**KNOXVILLE/KNOX COUNTY METROPOLITAN PLANNING COMMISSION
 SUBDIVISION REPORT - CONCEPT/USE ON REVIEW**

▶ **FILE #:** 4-SA-16-C
 4-D-16-UR

▶ **SUBDIVISION:** LAUREL RIDGE
 ▶ **APPLICANT/DEVELOPER:** IDEAL ENGINEERING SOLUTIONS
 OWNER(S): Ball Homes, LLC

**4-SA-16-C / 4-D-16-UR
CONCEPT PLAN/USE ON REVIEW**

SHEET ONE

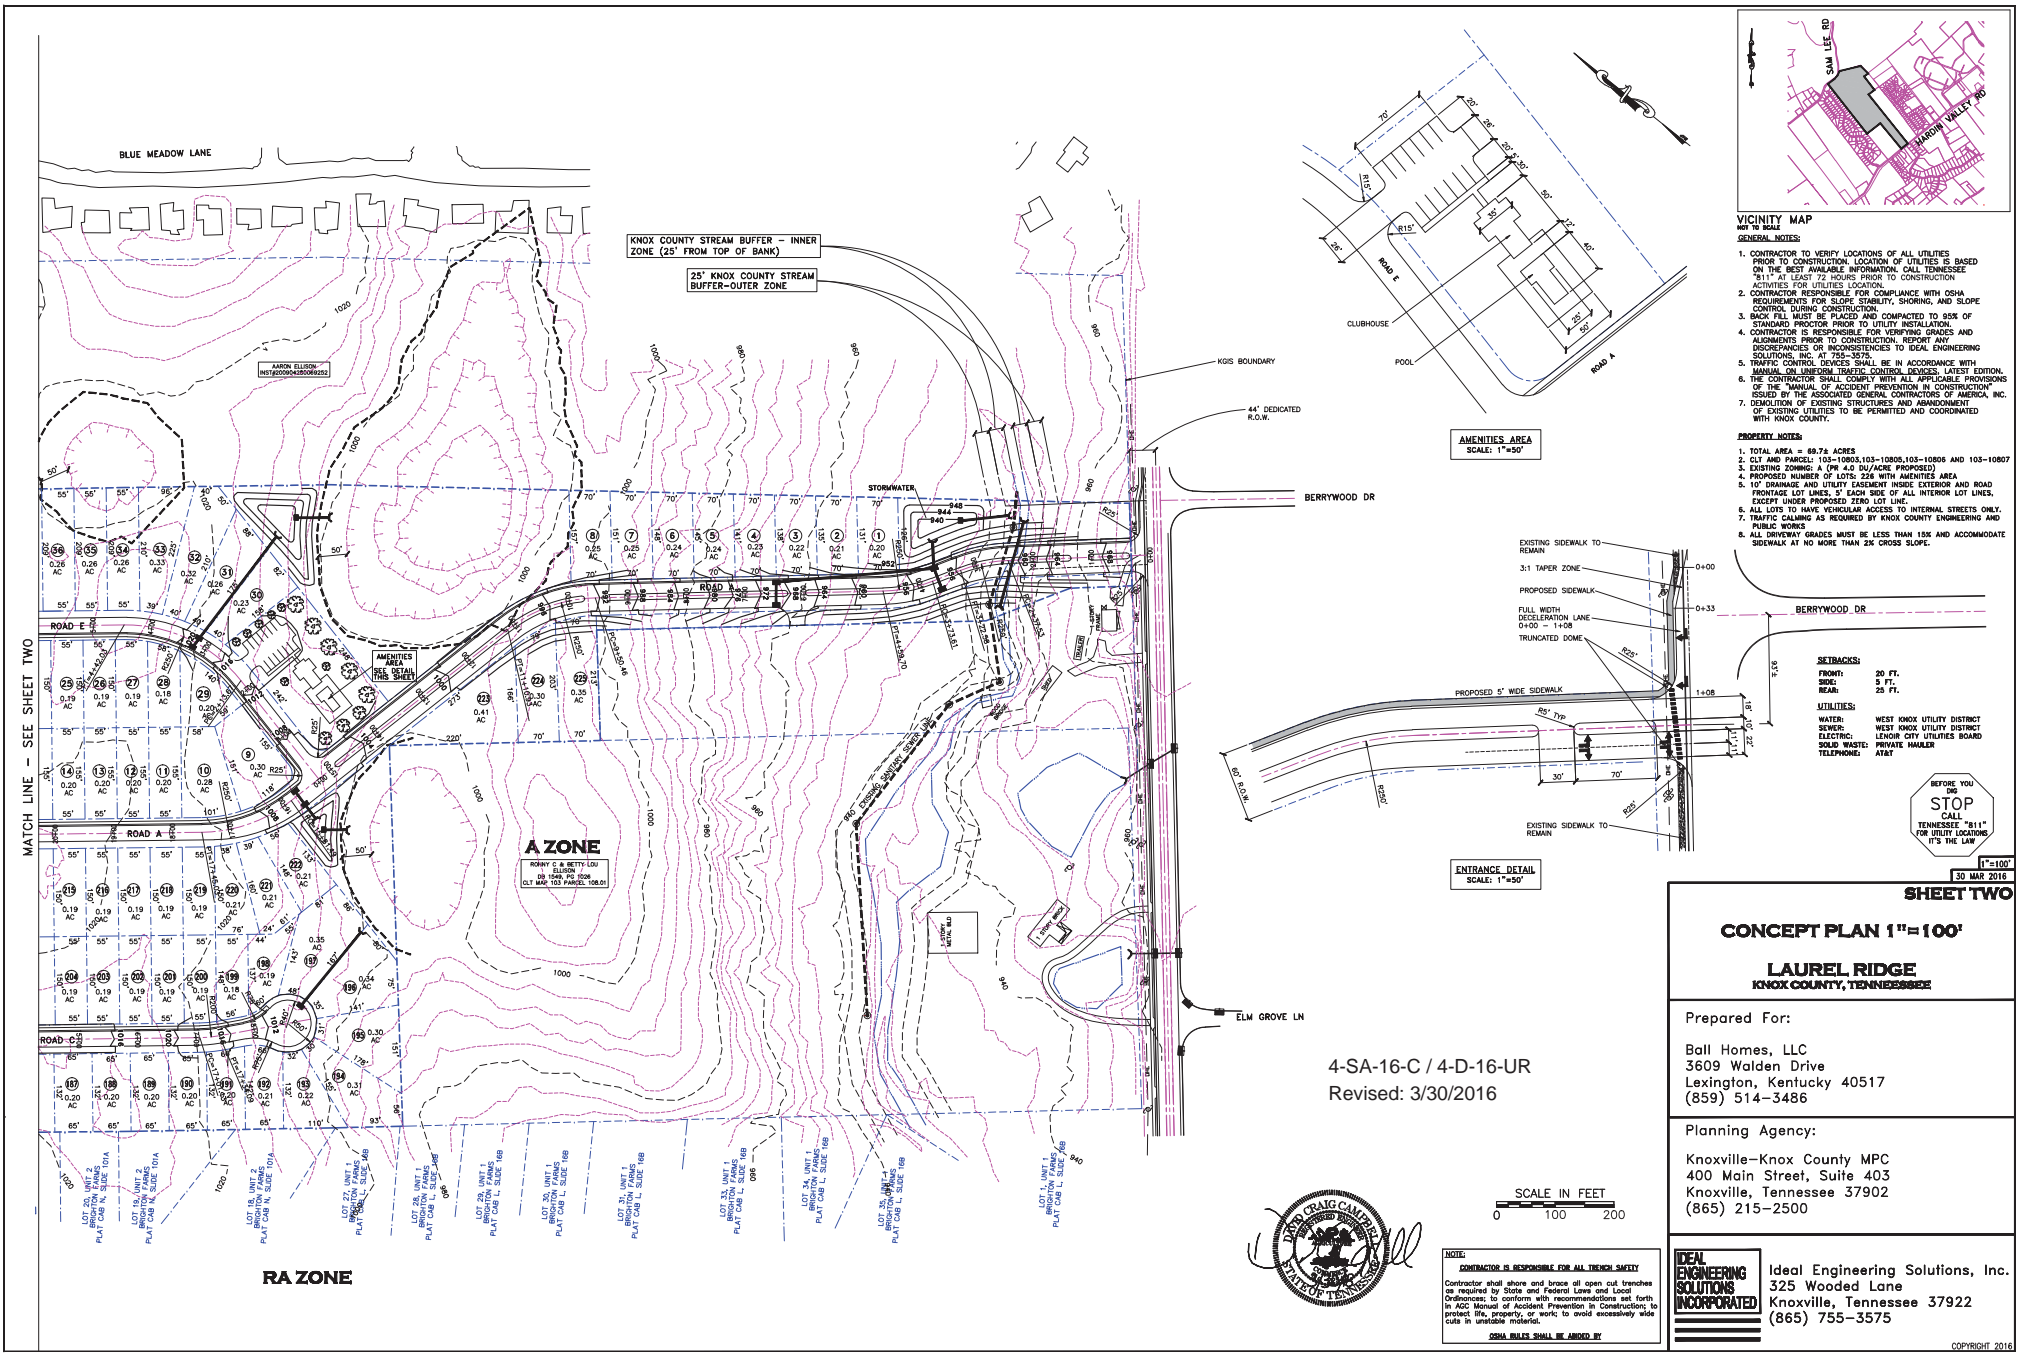
1. Reduction of the intersection spacing along Hardin Valley Rd., between Road A and Berrywood Dr., from 400' to 93'.
2. Reduction of the horizontal curve radius on Road C at STA 17+01, from 250' to 200'.
3. Reduction of the horizontal curve radius on Road E at STA 17+35, from 250' to 125'.
4. Reduction of the horizontal curve radius on Road E at STA 20+57, from 250' to 125'.
5. Reduction of the horizontal curve radius on Road E at STA 22+27, from 250' to 125'.
6. Broken back tangent variance on Road E between STA 21+73.45 and STA 22+26.55, from 150' to 53.1'.
7. Vertical curve variance on Road A at STA 0+60, from K=25 to K=15.96 (125' to 80').

4. Revising the concept plan to provide a stub-out street connection from Road A to the two large parcels located to the east and west of this site (Tax parcels 103-10801 & 103-10804) subject to approval by the Knox County Department of Engineering and Public Works and Planning Commission Staff.

5. The intersection of Road A with Roads B and D shall be designed as a two way stop condition.
6. Design of the temporary turnaround at the end of Road E subject to approval of the Knox County Department of Engineering and Public Works.

13. Including a line of sight easement on the final plat across Lots 57 and 58 in order to provide the needed sight distance for the curve in Road E.
14. Prior to certification of the final plat for the subdivision, establishing a property owners association that will be responsible for the maintenance of the common areas, recreational amenities and drainage system.

Staff has recommended a condition that a stub-out street be provided to the two large parcels located to the east and west of this site (Tax parcels 103-10801 & 103-10804). While these two parcels have frontage on Hardin Valley Rd., additional access points along Hardin Valley Rd. should be avoided when alternative access connections can be provided.

The preliminary site grading plan identified a potential problem with having adequate building sites in the area of Lots 74-89. Staff has recommended a condition that the applicant provide a detailed grading plan prior to design plan approval that documents that adequate building sites are available on all proposed lots.

- **APPROVE** variances 1-7 because the site's topography and shape restrict compliance with the Subdivision Regulations and the proposed variances will not create a traffic hazard.

APPROVE the Concept Plan subject to 15 conditions
